**Submission
No 11**

SYDNEY METRO WEST PROJECT

ATT: Submission on the Draft UDLP for the Rozelle Interchange.

Above: Noise-proof screening at North Strathfield around WestConnex Fly-ons

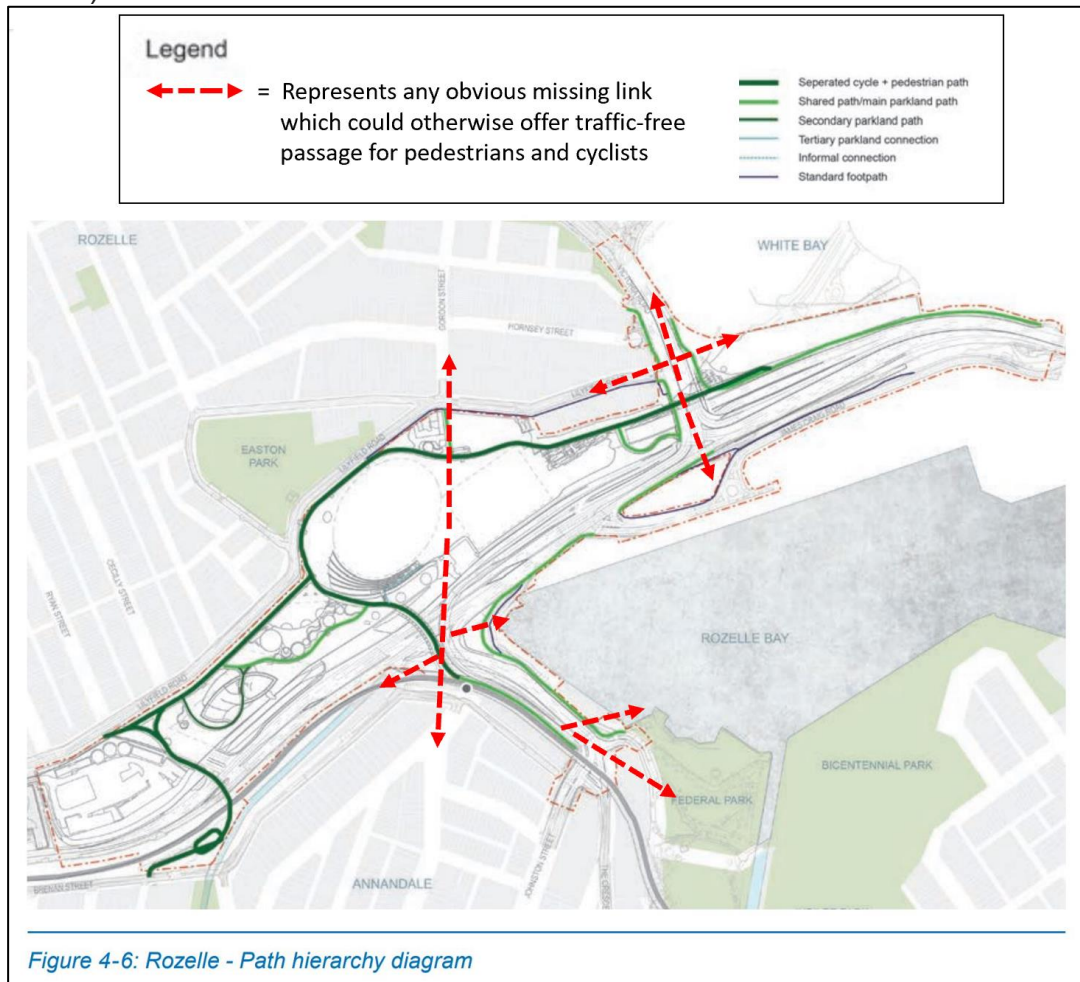
2. There should be no steel mesh walls ruining the views from any of the bridges your are providing. All should be built using glass walls, much like they did to block noise from the tunnel portals at the North Strathfield Interchange (see below).

These new glass noise barriers are excellent and cut out 95% of traffic noise for pedestrians standing behind them.

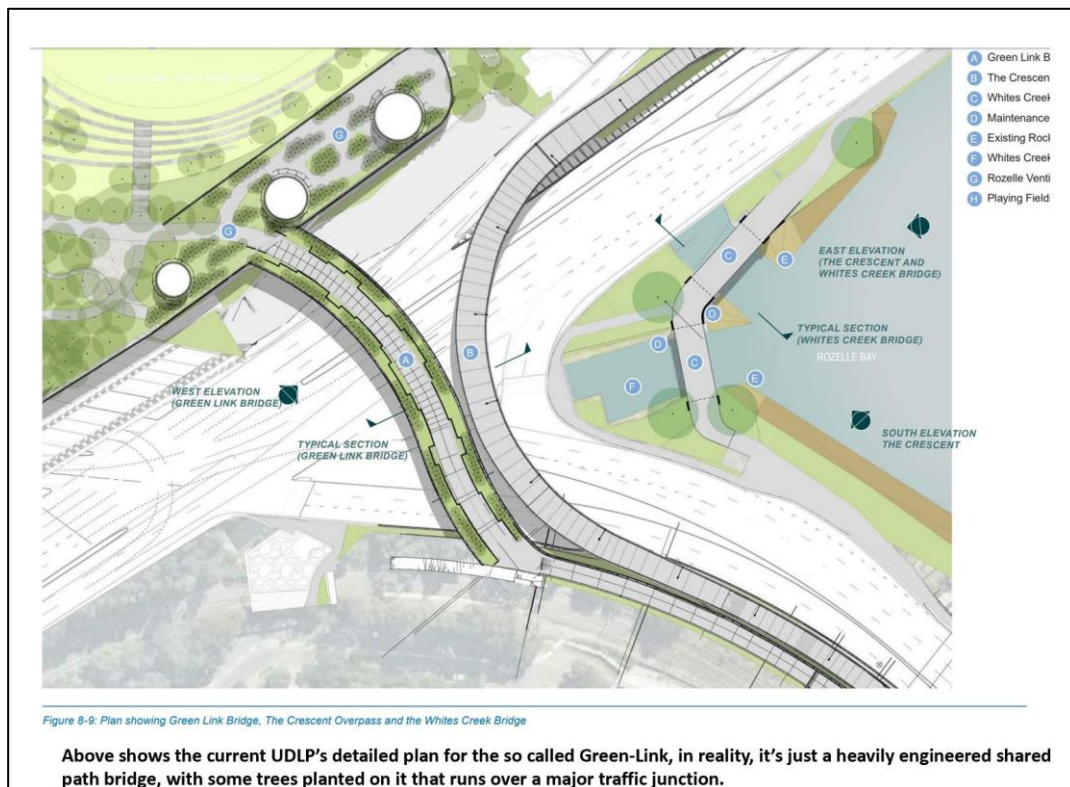
4. The New Victoria Road underpass (once completed) must be deep enough to allow for the passage of light rail vehicles between the new Parklands and White Bay. This is so some form of transit can one day operate off-road and interchange with the confirmed Bays Metro West Station on the White Bay foreshore.

Clearance for potential light rail really must be catered for now – as a potential light rail extension has been listed as an *'initiative for investigation in the next 10 to 20 years'* in no less than three of the State's most important and still-current infrastructure strategies. The strategies were all released in 2018 – and no, the confirmed Metro West plan does not supersede that initiative, in fact, it will be complimented by it. Because on this, it remains somewhat baffling (given the takeover of this project by TfNSW) that to date, this project (the Rozelle Interchange) fails to accommodate any reserved corridor on its surface that would allow for such an 'initiative for investigation' to remain cost-effective in future for the taxpayer.

In my view - it is simply not appropriate for TfNSW to build what they have described to me as 'essentially only a motorway project' now, in a way which might obscure or even sabotage the easy passage of light rail in future. Doing so could leave future light rail seeming cost-prohibitive despite what would be an obvious compliment to the region and The Bays, as an extension of the very successful L1 Inner West service.

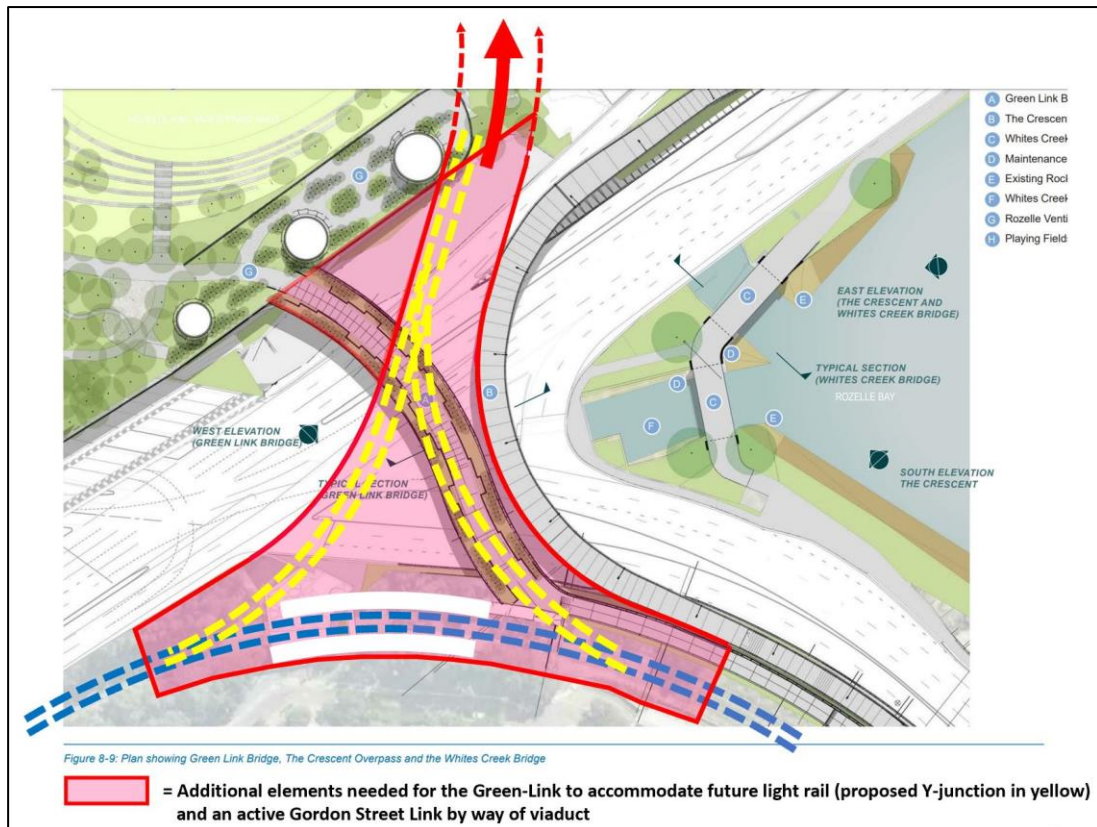
At present, I understand the new underpass (designed by JPB/John Holland) has been planned to be 4.5m in clearance at its highest point – but this slopes away to its south side slightly... If this results in the underpass not being high enough at its southern end for light rail, I imagine future engineers would need to excavate some of the ground below to increase the height of the underpass and thereby achieve the appropriate headroom for LRT vehicles. This would add to costs, lest light rail's passage through the underpass would become very tight indeed. Height is the issue, as it appears there is plenty of width in the underpass planned to accommodate light rail or other modes of transport in an east-west fashion (ie. 15m at its narrowest point and 28m at its widest).

Above: What the 'Village Green' will look like as planned in the draft UDLP (eastbound POV).

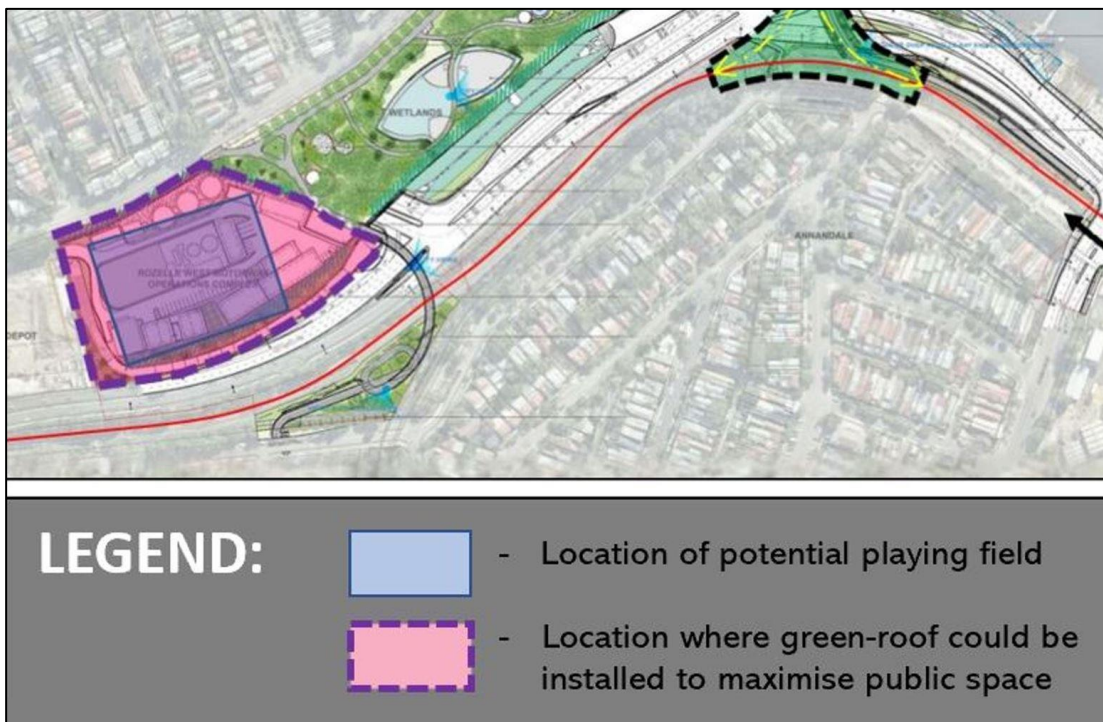
6. The Crescent Overpass needs to be redesigned as one large base platform over the CityWest, that not only accommodates cars on its fly-over, but the active Green-Link and a potential Y-junction (for light rail) that could feed a future transit link to White Bay. Such an elevated base platform or structure could be built on large stilts also filled with deep soil reserves that double as planter boxes capable of hosting new Port Jackson figs and other largescale vegetation, which would go some way to compensating those we lost in the now erased Buduwan Park. Such an outcome would be far more appealing than the shallow banksia plantings currently depicted along the narrow Green-Link bridge, which really is little more than an elaborate footbridge exposed to traffic noise with some mid-sized trees planted either side.

- I would like to suggest that a future reserved transit corridor should be looking to accommodate two tracks of light rail to White Bay from the existing Rozelle Bay light rail stop. Such a reserved transit corridor would require slightly more space to snake between the two proposed playing fields of the draft UDLP. Any land reservation for transit should be wide enough to accommodate another bricked-arch viaduct, like those the local community is already familiar with in Jubilee Park and Wentworth Park to the east - but this potential new viaduct (for Rozelle Parklands), should probably be designed 6 meters wider than it's predecessors, so that pedestrians and cyclists can also walk along it guaranteeing traffic-free passage alongside light rail, between Gordon Street and the Rozelle Bay light rail stop, not just through its arches below...

Above: The 'Village Green' could look like this (eastbound POV) with a rail viaduct imposed.

Above: The Motorway Facility to the west of the project is big enough to host a potential playing field and I will possibly sit below the cliff faces around it, so why not cover it over?

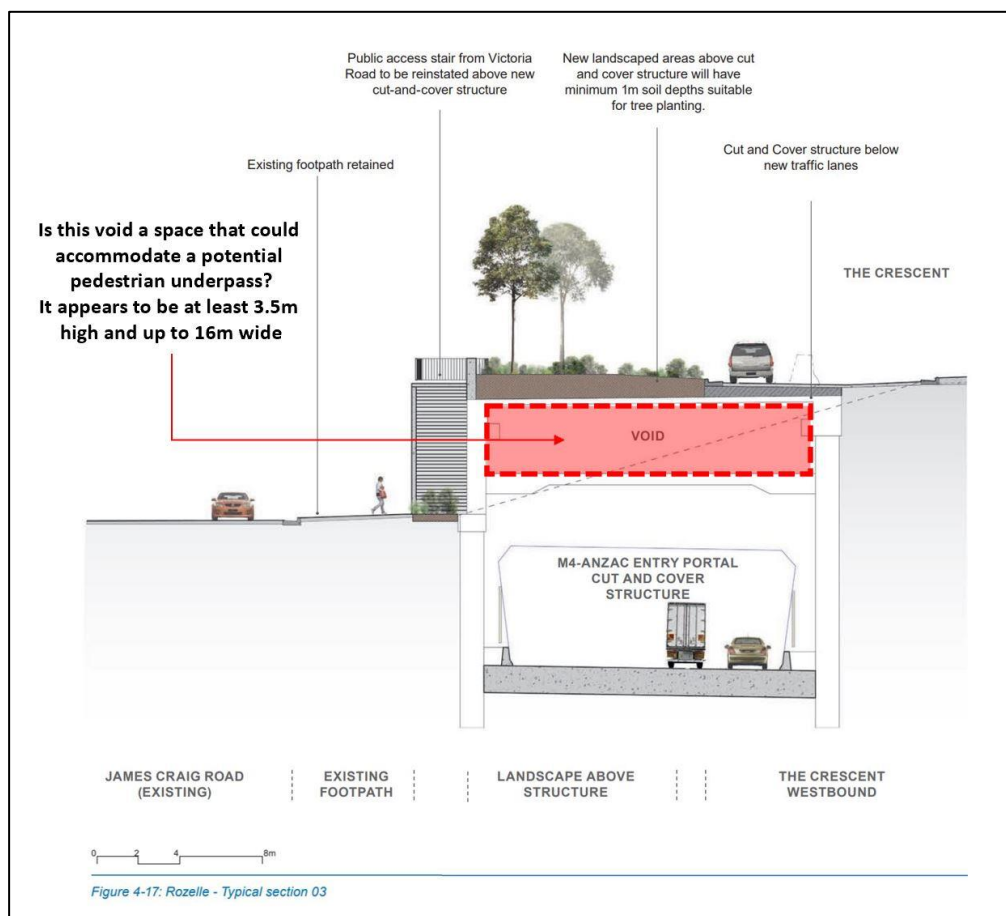
8. Why does the exit portal for the Iron Cove-Anzac Bridge tunnel need to be 'open air' and exposed to the parkland west of Victoria Road? Please cover it over and give more surface space back to park users – it would be an ideal place for some playing courts of a children's playground. This will also reduce traffic noise within the park itself.

Likewise, is it possible to cover the entire motorways operations precinct at the western end of the Railyards Parkland? What I mean, is if it is to exist in a dug-out part of the railyards, why not just hide it under a big green roof? If you did, this area could indeed be large enough to host another full-size football pitch.

Above: Horizontal beams indicate no passing vehicles will rise above their height, so why not cover them?

Above: This void could perhaps offer the key for connecting Rozelle Bay with the Rail Yard Park on the other side of the CityWest Link.

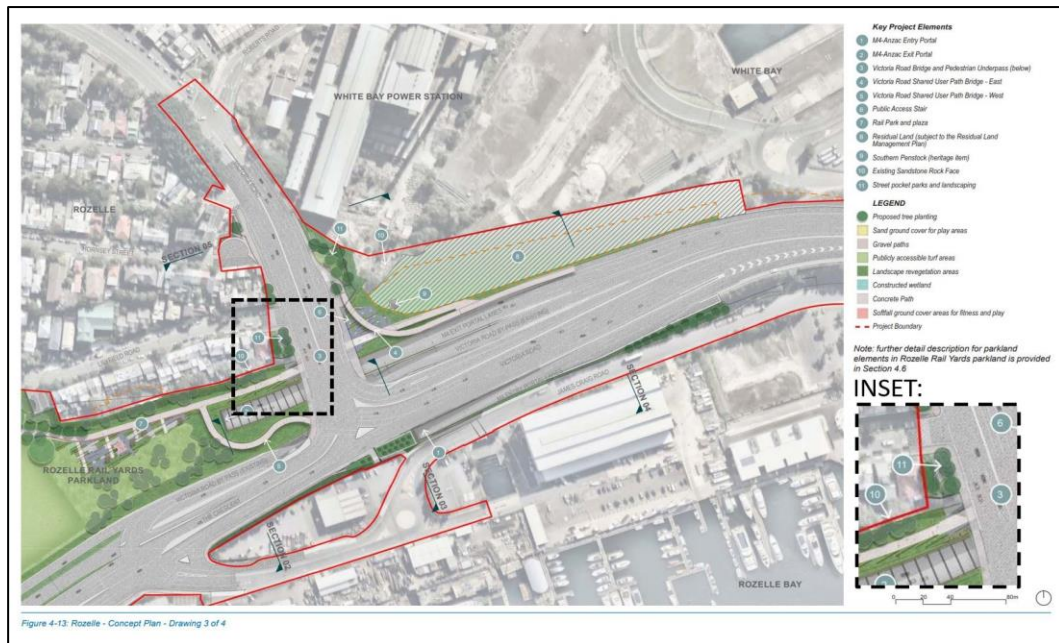
9. Is it possible to have the so-called 'void' depicted in Figure 4-17: Rozelle - Typical section 03 (p4-21), above the westbound tunnel cavity which is to pass from west of the Anzac Bridge, under the CityWest Link (westbound) and then into the terrain of the rail parkland above (to Iron Cove), to serve as a potential new pedestrian tunnel linking the Parkland in the Rail Park directly with Rozelle Bay foreshore? This would potentially obviate any need to cross the CityWest Link at traffic lights where it intersects with Victoria Road (a very unpleasant experience for peds and cyclists). The void depicted (according to the legend) certainly appears to seem high enough from the cross-section shown to host human pedestrians, and if not, could it be made so?

Above: Showing the position of the pocket park at the eastern end of Lilyfield Road that should offer a staircase down to Rail Yards Parkland to speed up the crossing of Victoria Road.

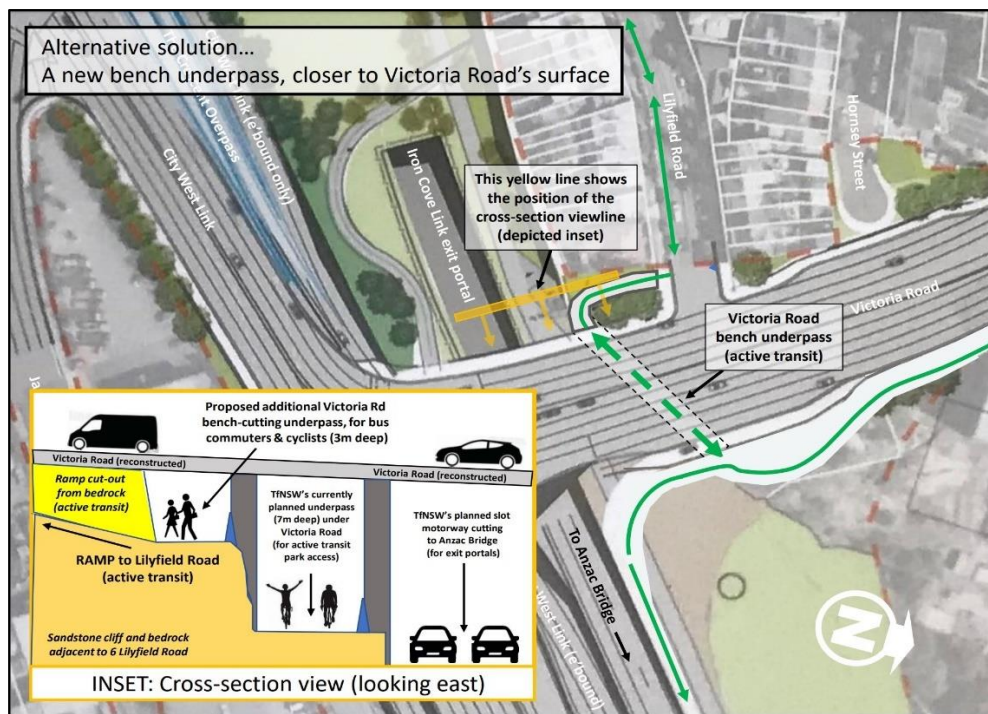
10. In "Figure 4-13: Rozelle - Concept Plan - Drawing 3 of 4" (shown below), it would appear the 'pocket park' listed (ie. Point 11) at the eastern end of Lilyfield Road, this is a wasted opportunity.

It truly beggars belief why the designers of the UDLP would not have grabbed the opportunity to at least provided a staircase or lift (or both!) at this location, down to the new Parklands from Victoria Road. It was at this southern end of Victoria Road where the former overpass once existed – which was incredibly important for local active movements for those living west of Victoria Road and the Anzac Bridge.

I know this better than most, because I once lived at 6 Lilyfield Road, the house immediately adjacent to this site. Why on earth would designers think to provide stairs on the eastern side of Victoria Road, but not on the western side? It's the western side, where the vast majority of residents wishing to cross to catch buses citybound live, so the change remains incomprehensible and will prove frustrating.

The terrain beneath your pocket park (Point 11) is solid sandstone – I know, once again I lived right next to it. To plant substantial trees or figs in that 'pocket park' would require some excavation and replacement of that sandstone with deep soil sinks – so I'm asking you to at least excavate some stairs as well, if that's what you're ultimately planning to do (like the UDLP suggests you will be doing on the eastern side of Victoria Road) to make a crossing of Victoria Road much faster for local residents who will be using it's bus services.

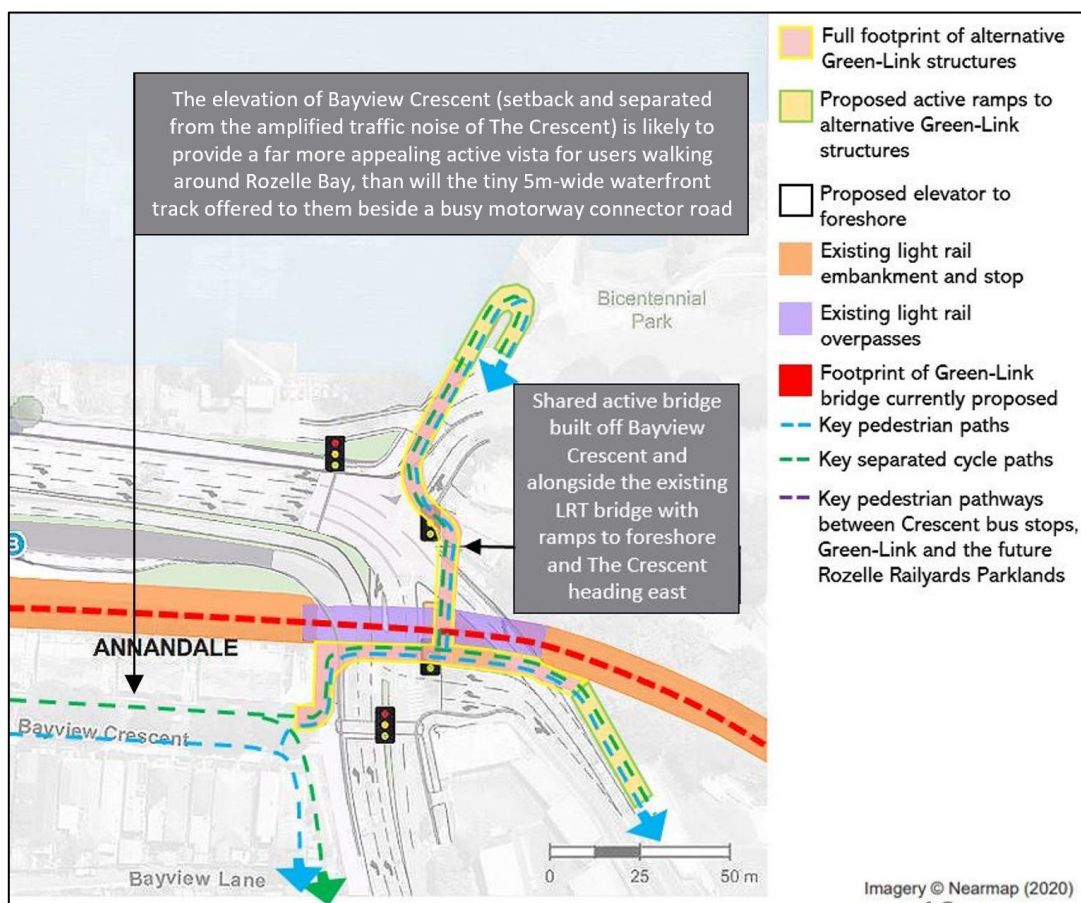
11. Again, it beggars belief why the designers of this Draft UDLP might try so hard to suggest they've designed a 'green-link bridge' which 'improves active movements across the CityWest Link' for people in Rozelle, only to have its users then forced into crossing an amplified version of The Crescent or Johnson Street on the other side! The intersections where these pedestrians and cyclists must now cross over these roads should (in my opinion) also be provided with overhead crossings of their own – involving new shared-path bridges.

Such additions needn't be so-called 'green' or built at exorbitant in cost – they could be made affordable using lightweight but high-tech composite materials like those being manufactured in Queensland by Australian-owned Wagners¹. These could be custom designed and shipped to NSW by flatpack, before being assembled on-site and 'snapped-on' to side of existing structures.

For argument's sake, one could be snapped on to the southern side of the light rail bridge which lies east of The Crescent. In this way, a single design might cater for crossings of both Johnson Street and Chapman Road, allowing active users from all residential areas (ie. Annandale *and* Rozelle) to avoid traffic interactions altogether, across the amplified Crescent and Johnson Street.

Above: The Crescent/Johnson Street Overpass Suggestion

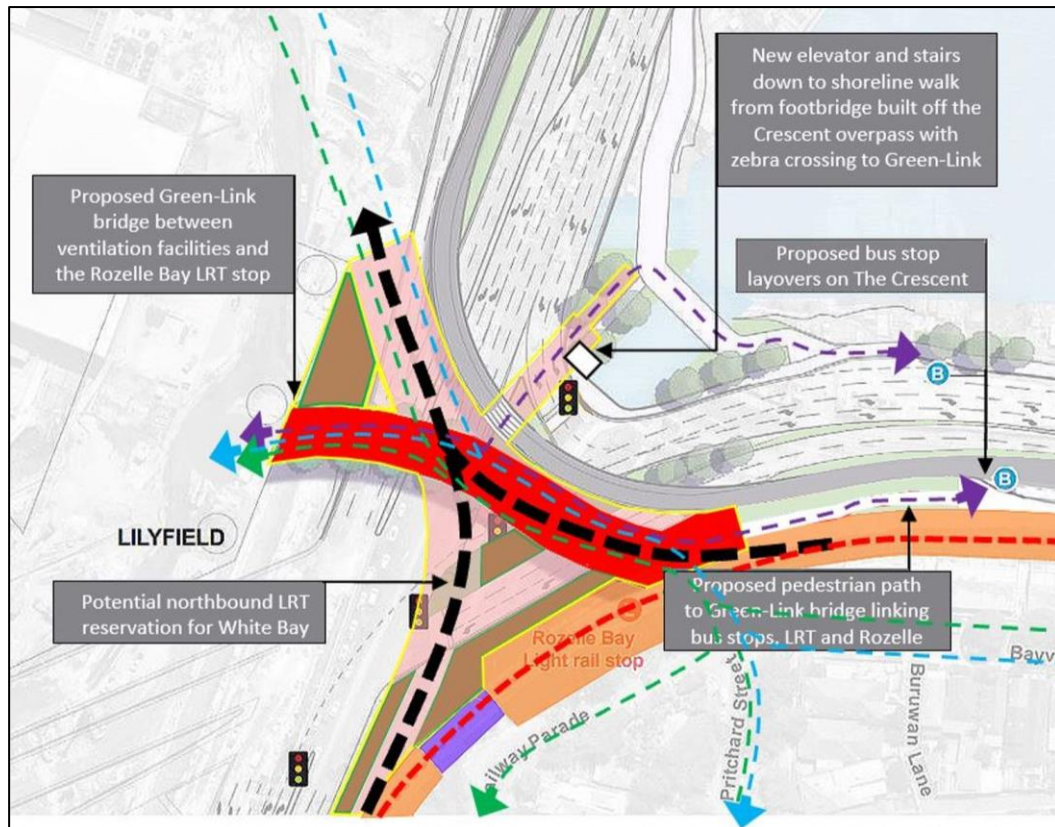
The suggested 'snap-on bridge' could have ramps that head back to ground in an eastbound fashion, linking with Minogue Crescent on the other side of the rail bridge and the Bicentennial Parklands. It could also offer a level-crossing of the existing light rail bridge (much like those currently found at existing light rail stops). This would then allow for a crossing of Chapman Road as well, and the declining gradient down to the foreshore on the other side – again, this would be a liberating connection for users, free of all traffic (see image below).

A secondary bridge could also be built off the Crescent Overpass itself down to the Rozelle Bay foreshore, if combined with a raised zebra crossing (wombat crossing) over the carriageway, that could allow people to move directly from an expanded version of the Green-Link (built adjacent to the Crescent Overpass) to bridge safely from Rozelle to cross over safely to the Foreshore Park much more efficient.

Above: A hypothetical Crescent pedestrian overpass to Rozelle Bay Foreshore (and surrounding links)
